ADDENDUM NO. 1
Amelia River Waterfront Stabilization Parking Lots C & D
City of Fernandina Beach
Invitation to Bid # 21-06
Issued: May 25, 2021

III. Changes to Drawings: (See attached)

Drawing name: F:\PASSERO\FHB\99000047.0095 FHB Waterfront\Airport\C5-01-PROF_XSCT.dwg C6-4_XSCT May 25, 2021 5:56am by: EBredestege

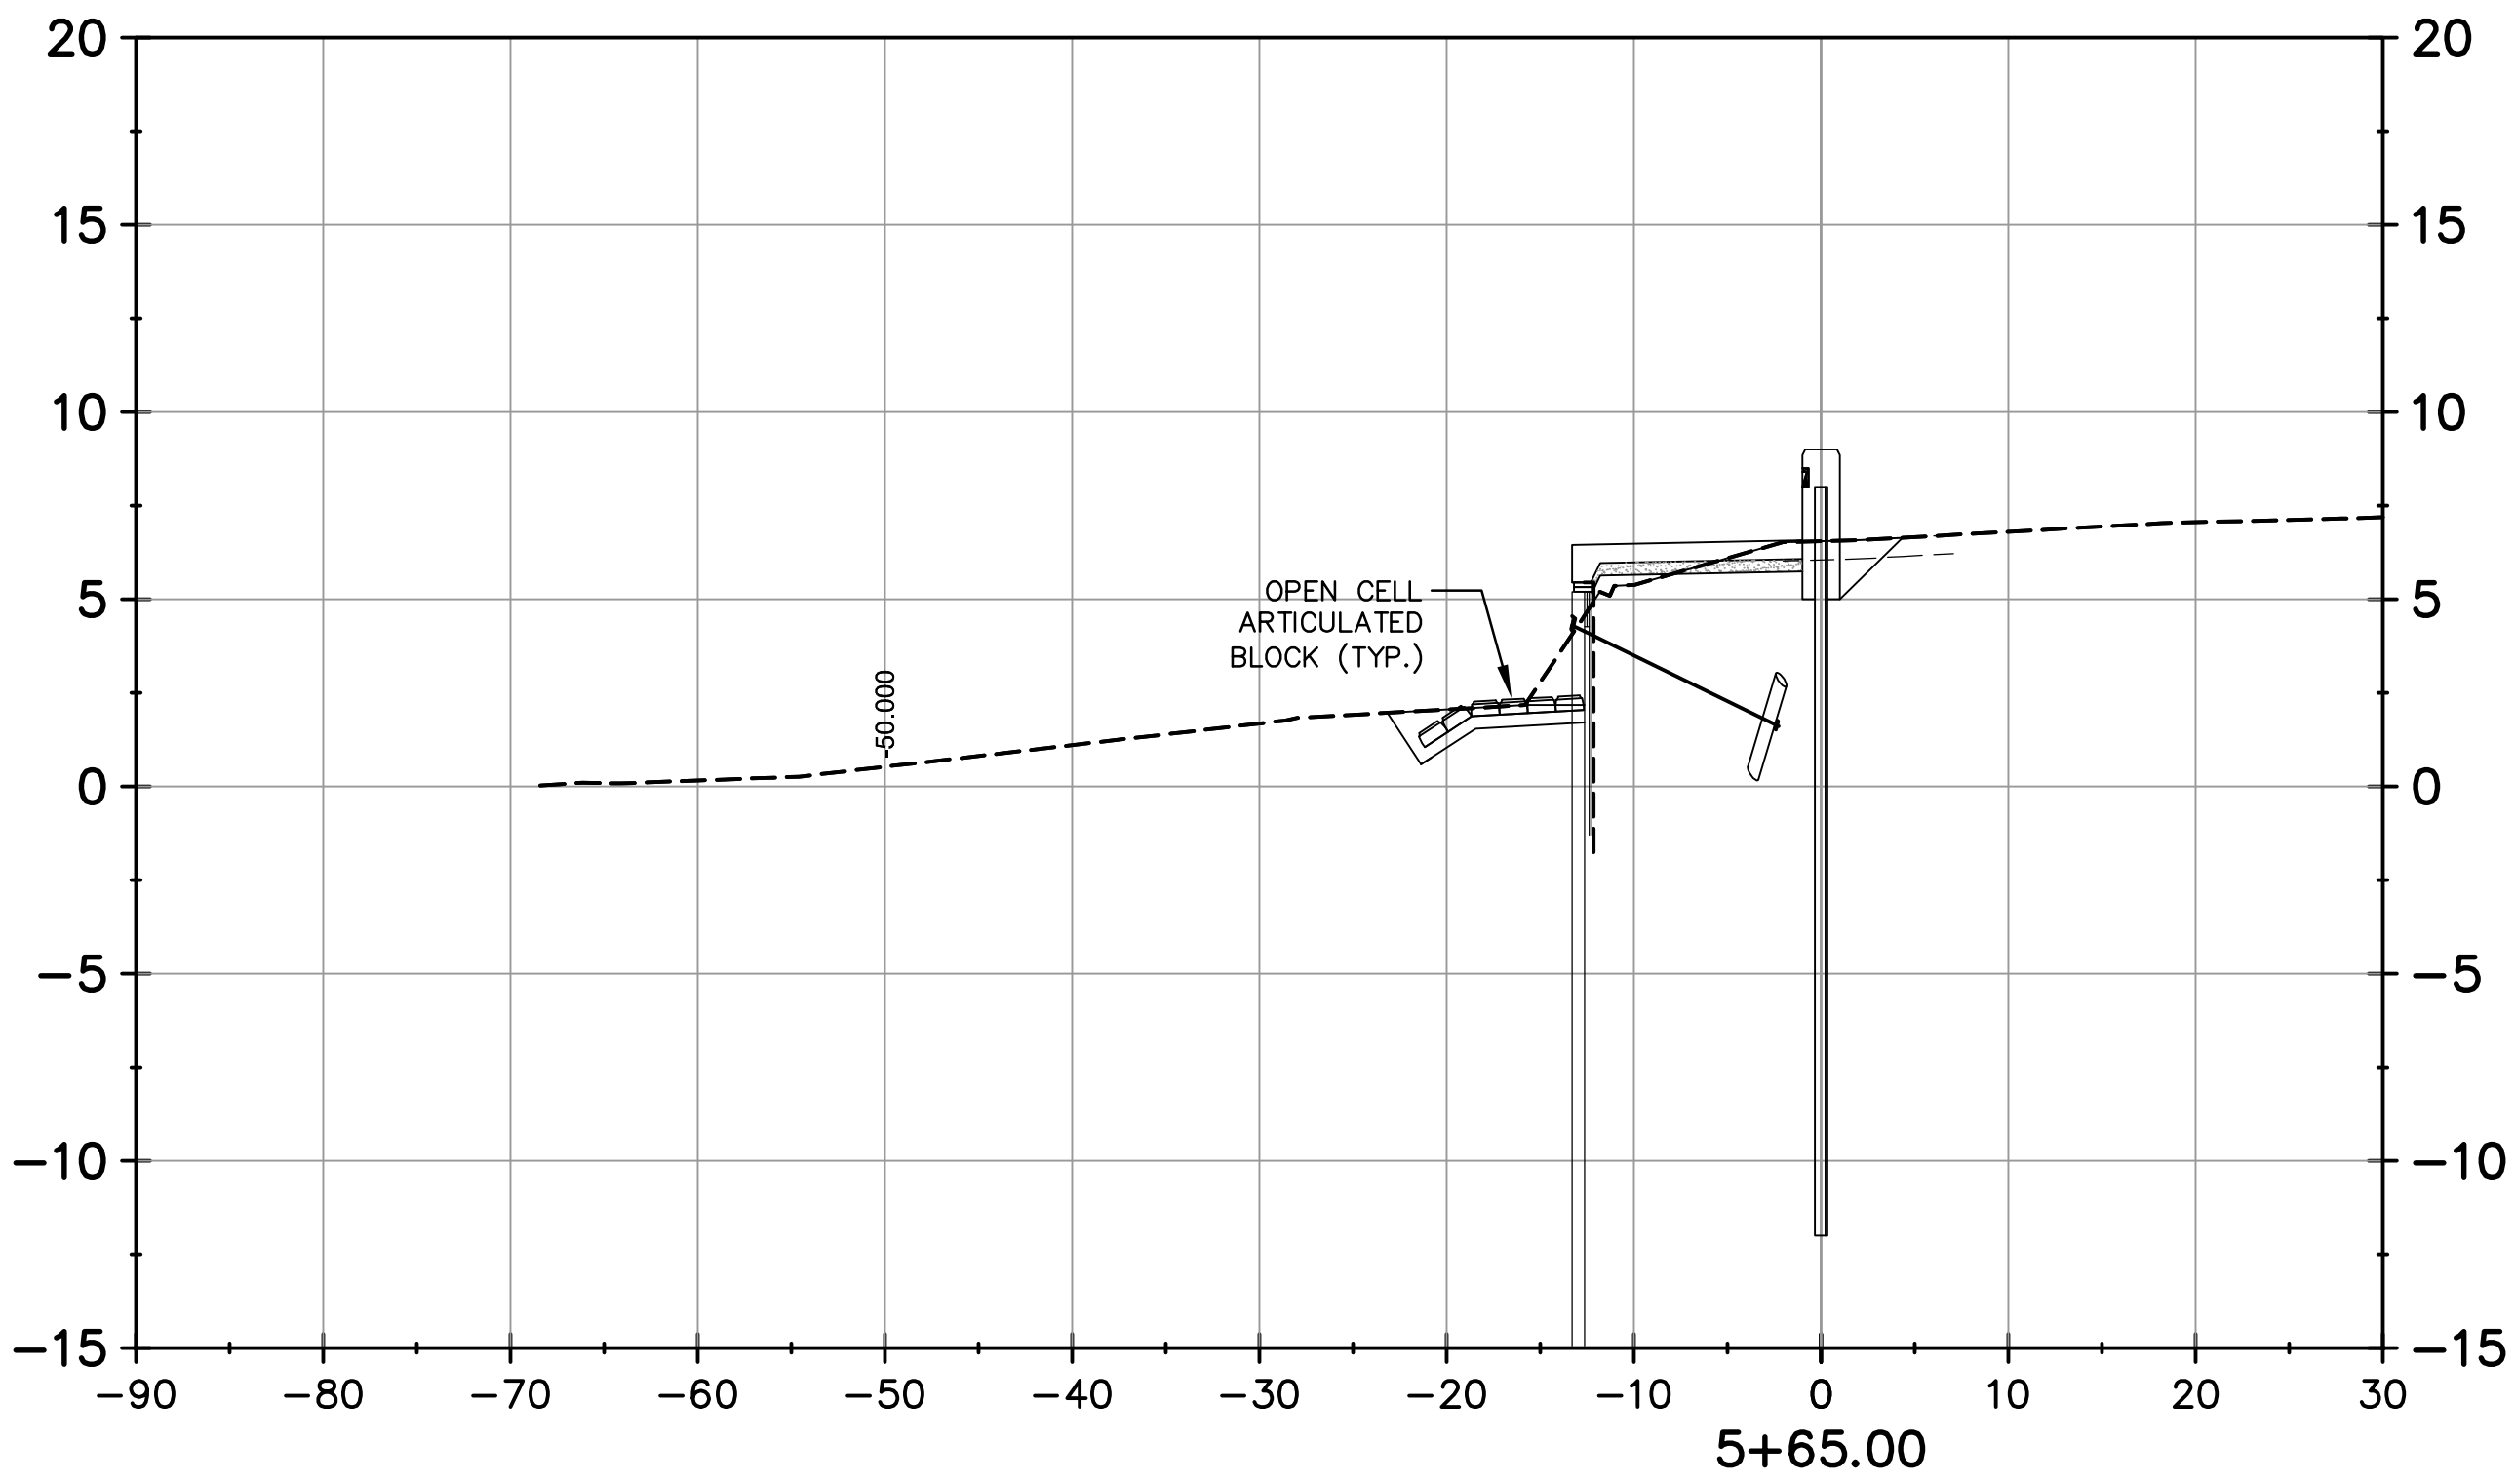
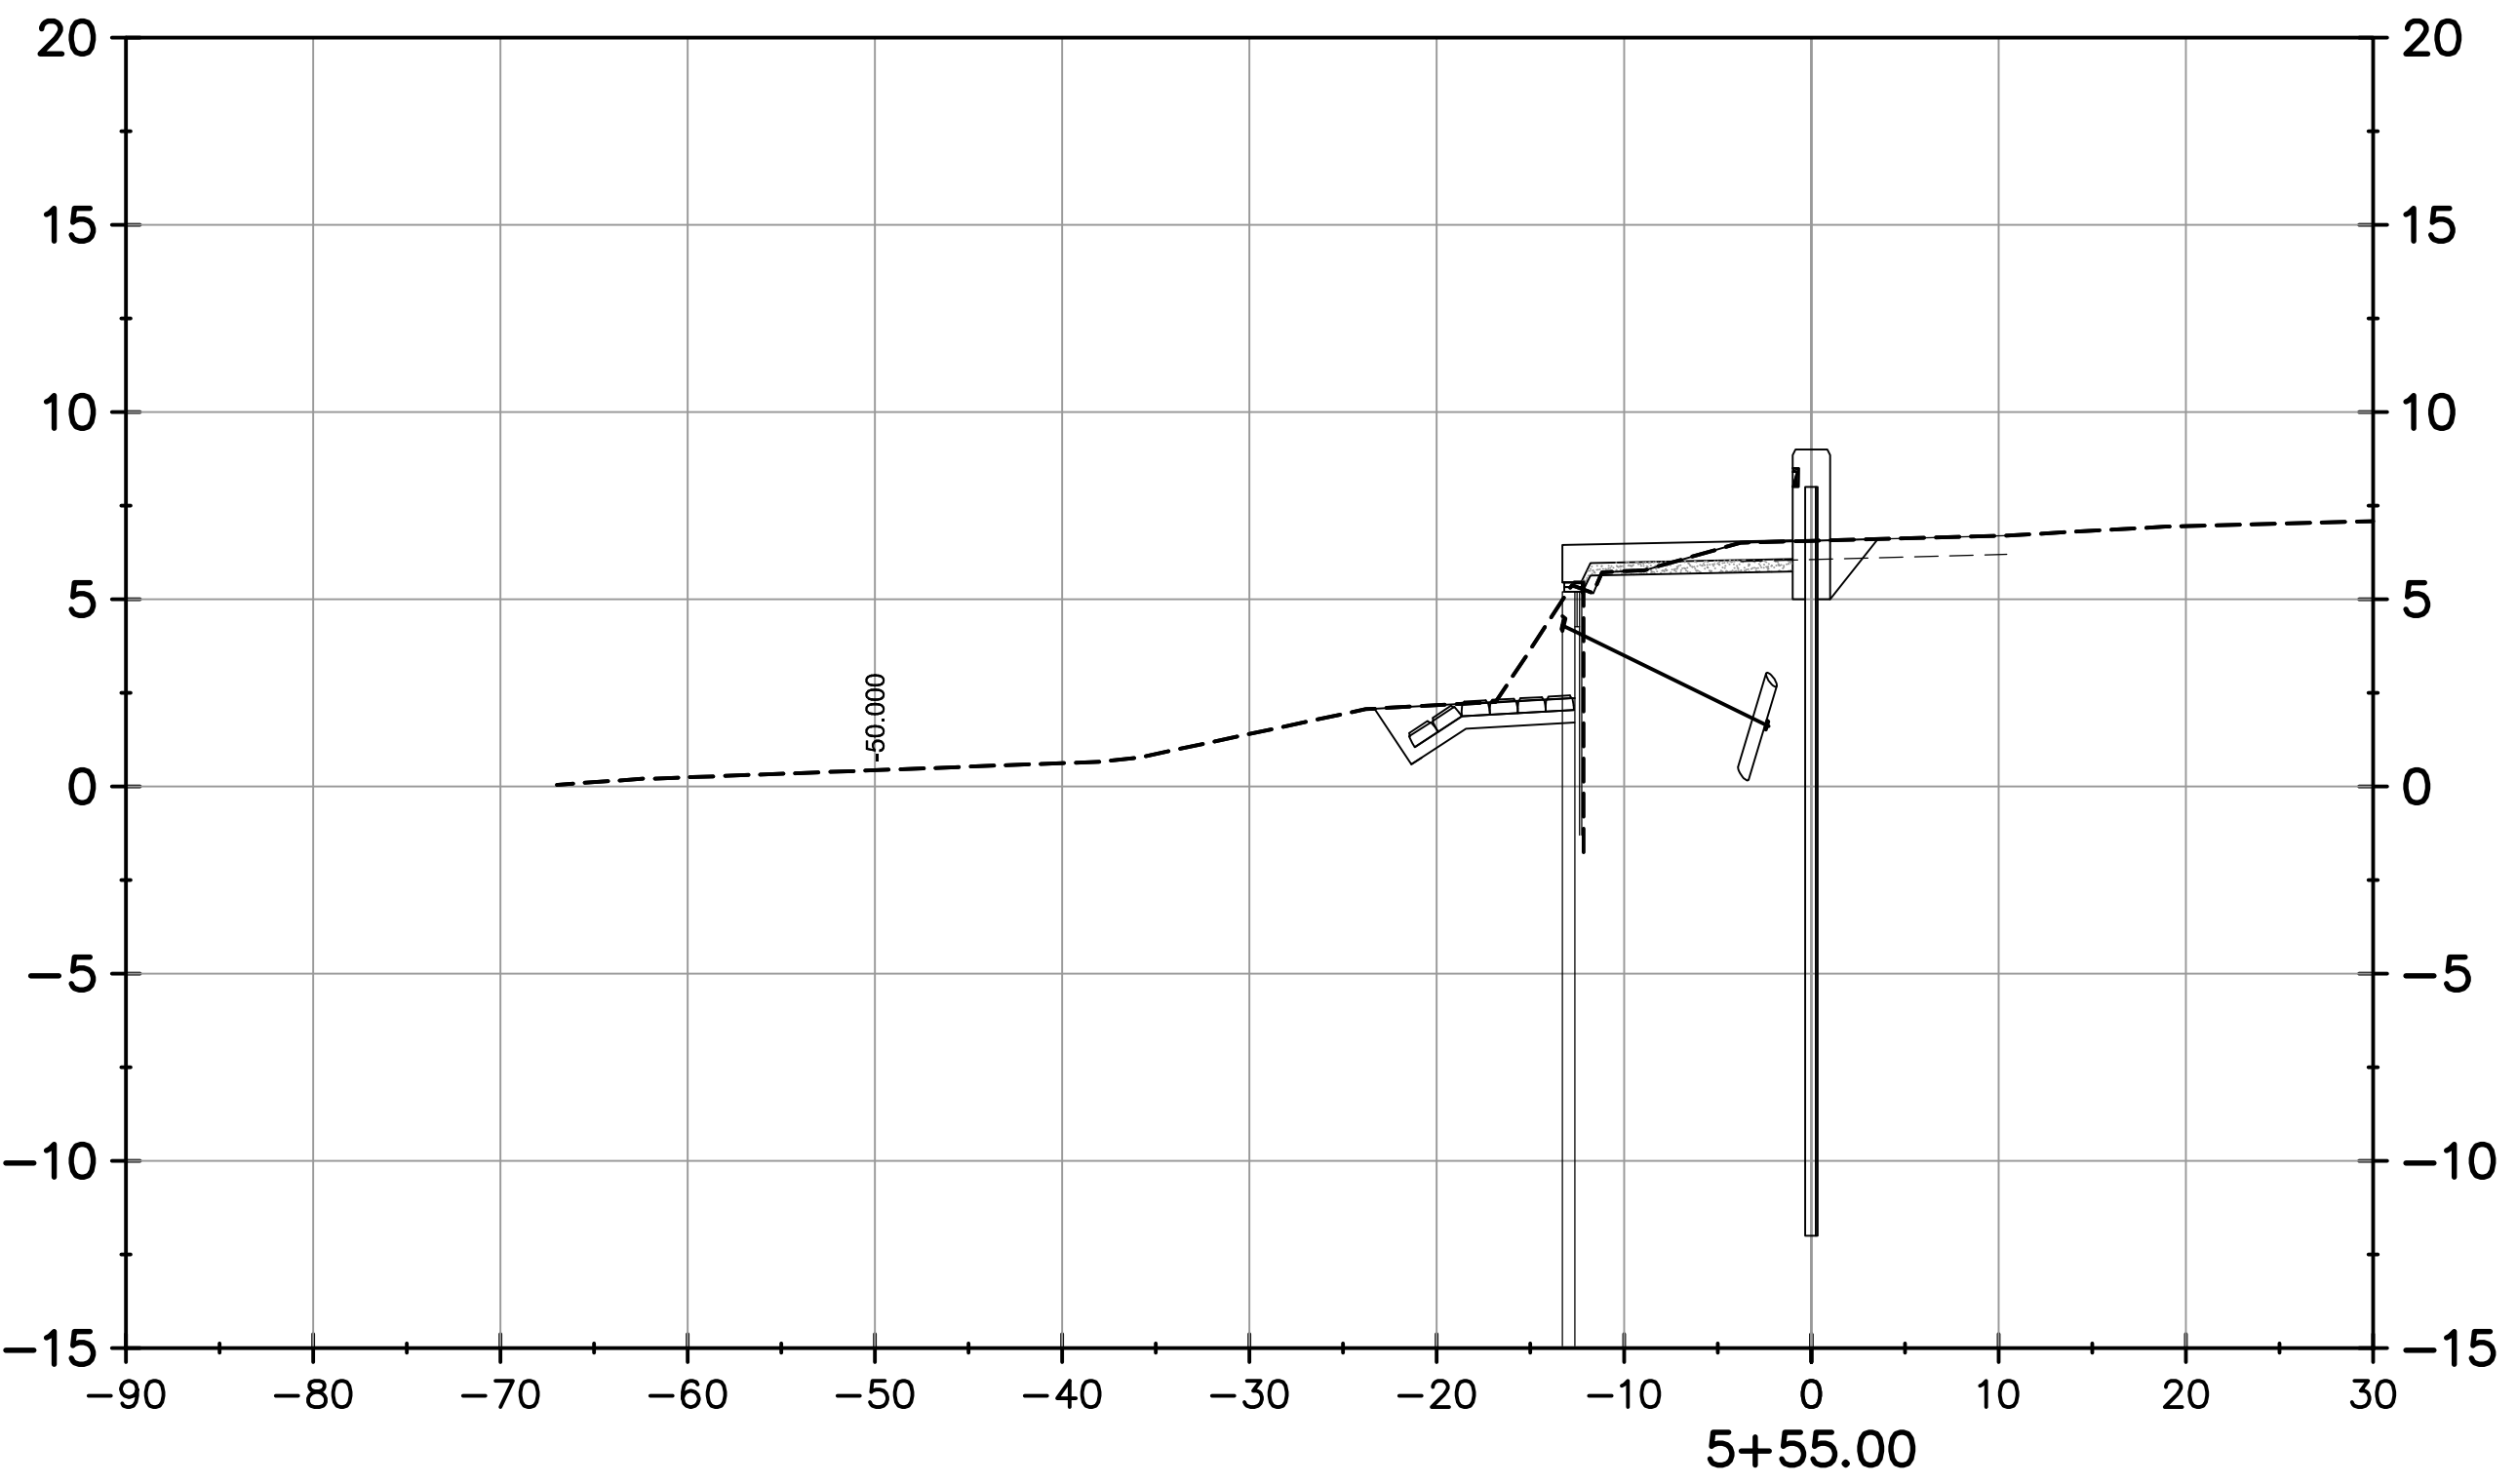
- 22) Sheet C6-3 - Revised I-Wall & Boardwalk Alignment and Cross Sections Adjusted.
- 23) Sheet C6-4 - Revised I-Wall & Boardwalk Alignment and Cross Sections Adjusted.
